**ATTACHMENT K**

County of San Mateo

**SUBJECT:** Summary of Comments and Questions Received at the Public Workshop Held on November 28, 2007 for the Proposed Mixed Use Office Facility, Requiring Rezoning from R-1/S-92 to PUD (Planned Unit Development), and General Plan Amendment from "Medium-Low Density Residential" to "Office Commercial," Located at 2126 and 2128 Sand Hill Road in Unincorporated Menlo Park (APNs 079-120-160 and 079-120-140)

**Subject:** Planning Commission Hearing, 26 August 2009  
**Re-Zoning:** 2126 & 2128 Sand Hill Road  
**File Number:** PLN 2008-00136 (Bauger)

**Floor Plan showing Screen of Trees in front of proposed project**

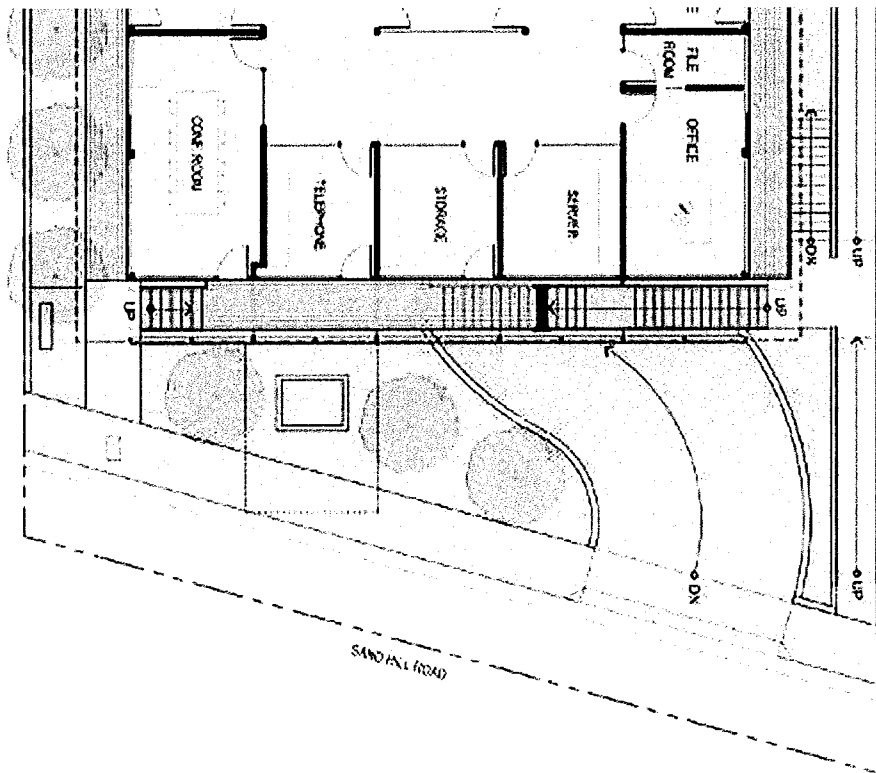
- 1. Not grant the change in zoning without adding a provision to the project that mandates the planting and maintenance of a screen of trees between the building and Sand Hill Road to act as a buffer.**
- 2. Consider the larger concerns (findings of Planning Commission, March 2009):**
  - The bulk and positioning of the building is not harmonious with the surrounding land uses.
  - The setbacks are inadequate in the front and side yards, as compared to those on surrounding parcels.
  - The project conflicts with the general plan with respect to encouraging urban sprawl.**Return the project to the Planning Commission with a recommendation that the project be scaled down by increasing the front setback.**

Sand Hill Road is designated as a "Scenic Road." A 'Scenic Road' is described as a travel route that should provide attractive urban development. Unfortunately, the project provides no buffer of trees between the front of the commercial building and the street. Without a buffer of trees in the front similar to what is on all of the other properties from the corner of Santa Cruz and Sand Hill Road to the Sharon Shopping Center, the large office building will create an eyesore, and look like "urban sprawl." Any design that encourages urban sprawl conflicts with the general plan.

If one moved the building back another five to ten feet, or reduced the size of the building, or both, there would be enough space for tree roots to grow and create a necessary buffer in front. A buffer of trees and plantings would create a desirable shield, make the development harmonious with surrounding land uses, and maintain Sand Hill Road as a 'Scenic Road.'

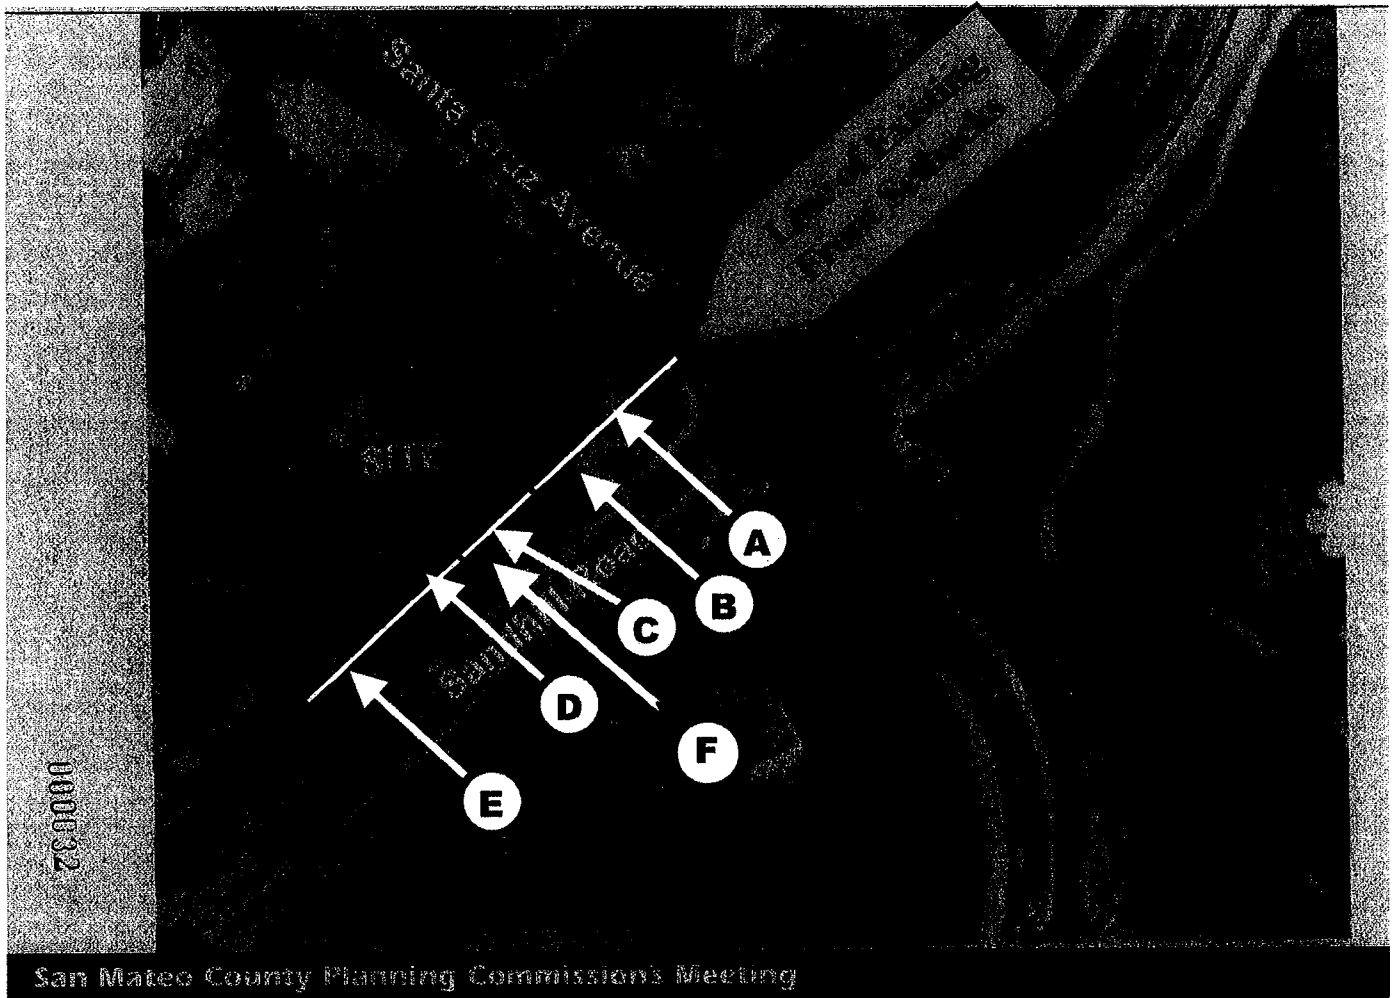
With the proposed position and height of the building, the view and privacy I once enjoyed will be gone. If the building were setback 20 feet further from the street, I would still lose my sense of privacy but at least I would retain some semblance of my view. The redwood hedge between White Oak and the project is important for maintaining my privacy.

NO. 0011 REVISED  
2775 SAND VAL DRIVE  
MENLO PARK, CA  
A102 ALT

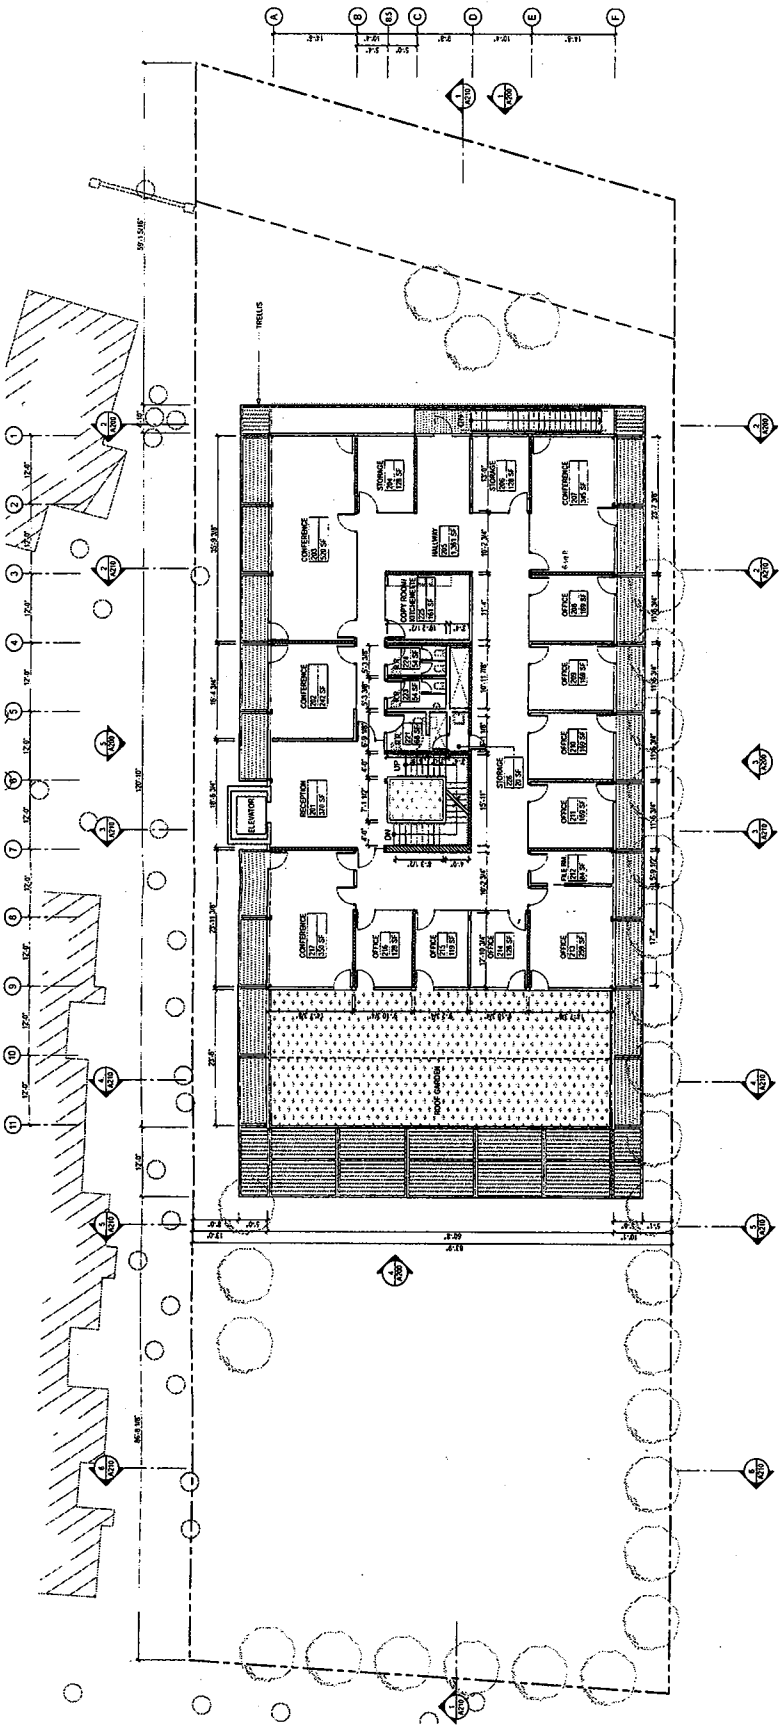
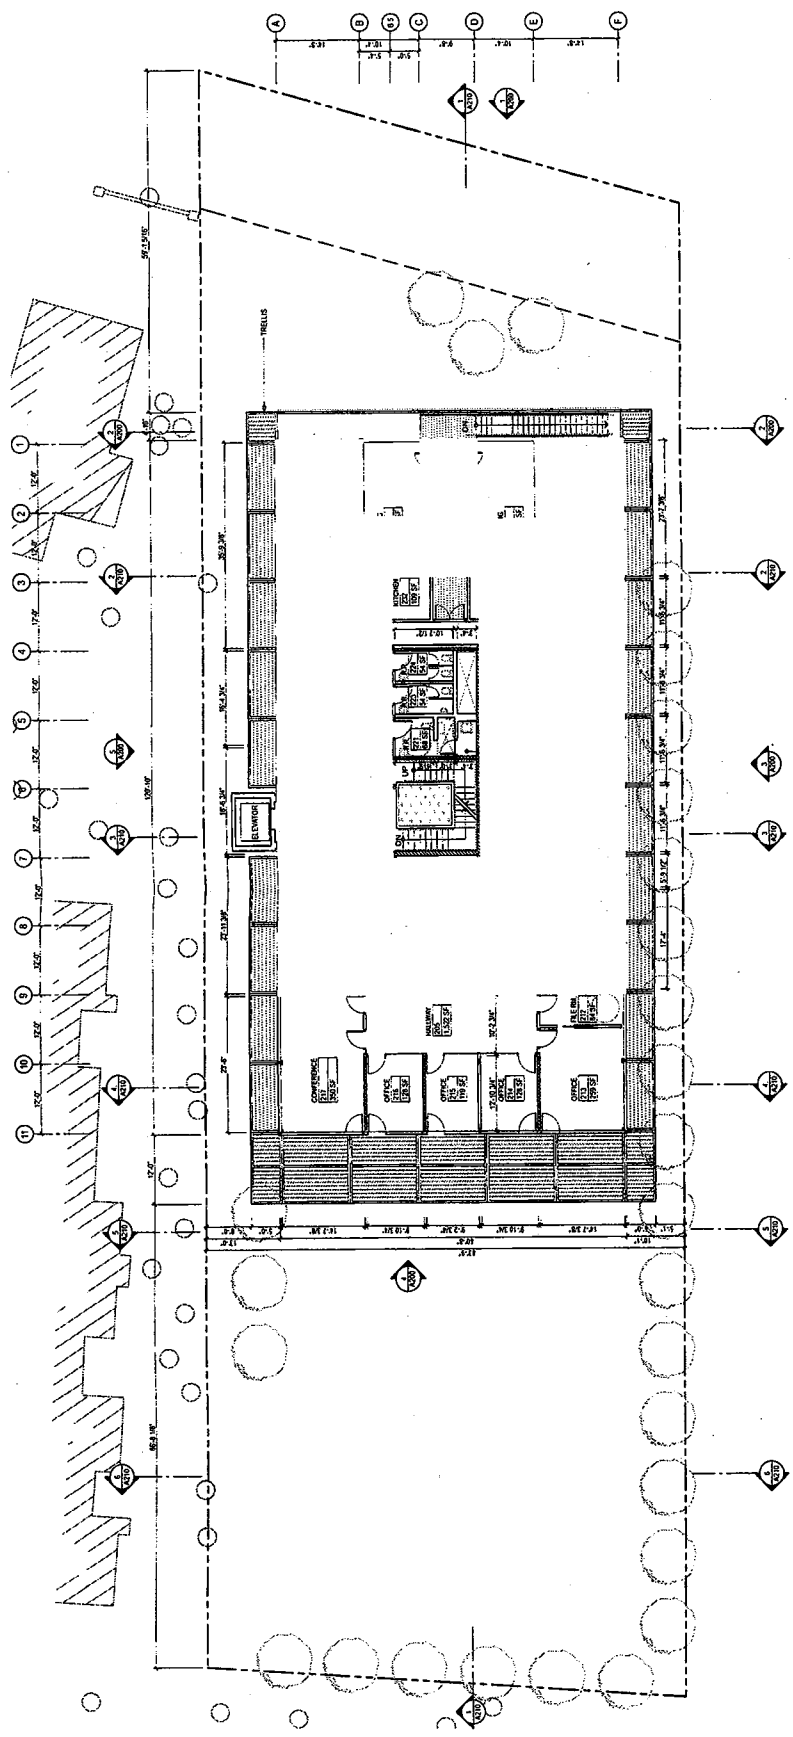
In Plan 1, on the other hand, the second floor must extend the full length of the first floor to accommodate the two residential units. Since the entire building is now set back 16 feet further from Sand Hill Road, a full-length second floor blocks a significant amount of light that would otherwise reach Pacific Hill. In this respect Plan 1 is demonstrably worse than Plan ALT and demonstrably worse than the original plans submitted in March 2009. Extensive light and shade studies were conducted with respect to the March 2009 plans. Have these studies been redone to demonstrate the effect of Plan 1? If they were conducted, they would show the considerable decrease in the light reaching each floor of Pacific Hill. (As noted above, the ground level of our property is several feet below the ground level of the proposed building site, which places our first and second floors below the level of the second floor of the proposed building.) Therefore, Plan 1 is clearly much worse for the residents of Pacific Hill and, no doubt, for the other surrounding communities as well.

<sup>1</sup> The ALT Plan and Plan 1 are identical except for the second floor. The ALT Plan is labeled "A102 ALT" and titled "Second Floor: Alternate w/o Residential." Plan 1 is labeled "A102" and titled "Second Floor." We note that there was a printing error in the copy of Plan 1 that we received. Consequently, our copy of Plan 1 does not show the residential apartments at issue.

Plan 1 is materially worse for our complex because it retains the two residential apartments on the second floor facing Sand Hill Road. In Plan 1, the second floor must extend the full length of the first floor to accommodate the two apartments. Since the entire building is now set back 16 feet further from Sand Hill Road, this change blocks a significant amount of light that would otherwise reach Pacific Hill. Plan 1 is demonstrably worse in this respect than either the ALT Plan or the plans submitted in March 2009. Extensive light and shade studies were conducted with respect to the March 2009 plans. To our knowledge, these studies have not been redone to demonstrate the effect of Plan 1. If they were conducted, they would show the considerable decrease in the light reaching each floor of Pacific Hill. As we have said previously, we fully support a commercial building as our neighbor. We do not, however, support Plan 1, which will drastically reduce our light and view with no benefit to our community.
